Rezoning Application: PD 25-0371

Development Services Department

1.0 APPLICATION SUMMARY

AGENCY REVIEW COMMENT SHEET

7.0 ADDITIONAL INFORMATION AND/OR GRAPHICS (See following pages)

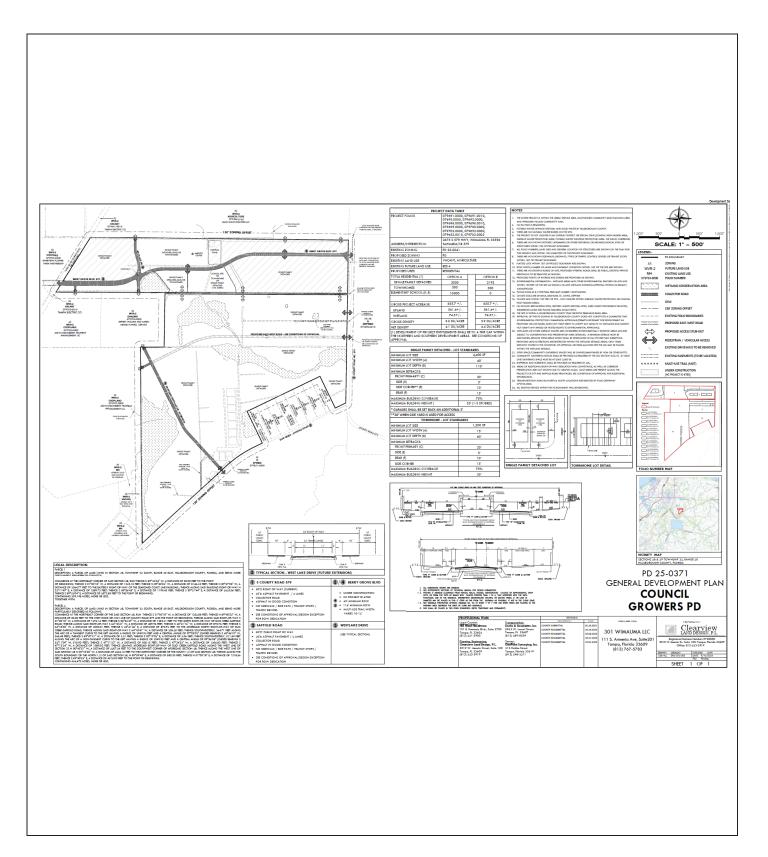
- 1. Within the Project Data Table, add footnote "(1)" to "Elementary School K-5" such that it is apparent the trip cap applies to all development within the project, not just total residential.
- Within the Project Data table, correct the number of Elementary School students from "10000" to instead state "1000 students max."
- 3. Within the Project Data table, revise "Proposed Uses" line from "Residential" to instead state "Residential and Potential School".
- 4. Revise the Berry Grove Blvd. Typical Sections to remove any references to "Tier 1-1".

- Prior to certification of the General Development Plan (GDP), the applicant shall revise the PD site plan to:
 - Within the Project Data Table, add footnote "(1)" to "Elementary School K-5" such that it is apparent the trip cap applies to all development within the project, not just total residential.
 - Within the Project Data table, correct the number of Elementary School students from "10000" to instead state "1000 students max."
 - O Within the Project Data table, revise "Proposed Uses" line from "Residential" to instead state "Residential and Potential School".
 - o Revise the Berry Grove Blvd. Typical Sections to remove any references to "Tier 1-1".

TYPICAL SECTION. SEGMENT A

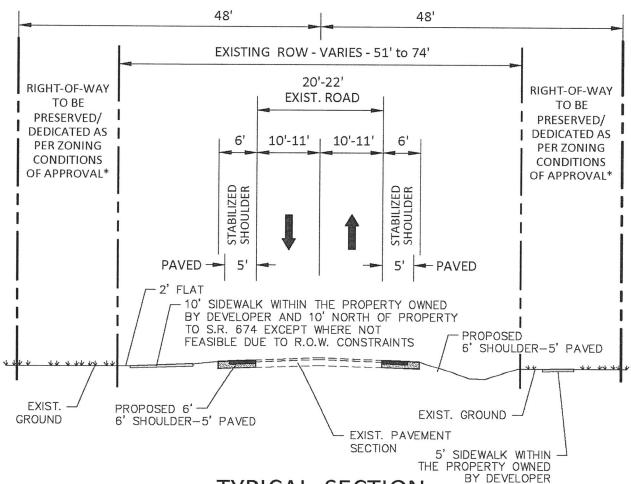
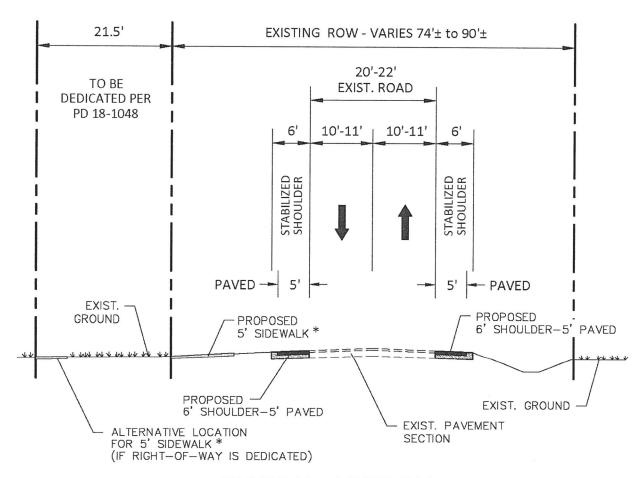
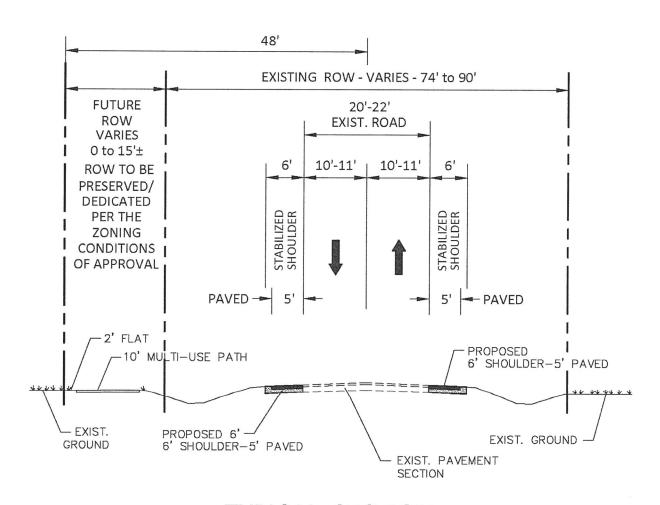
Staff noes that the graphic shown in the Design Exception request incorrectly depicts Segment A as inclusive of the area covered by Segment B. Staff has updated the graphic to reflect the correct summary and segmentation described hereinabove.
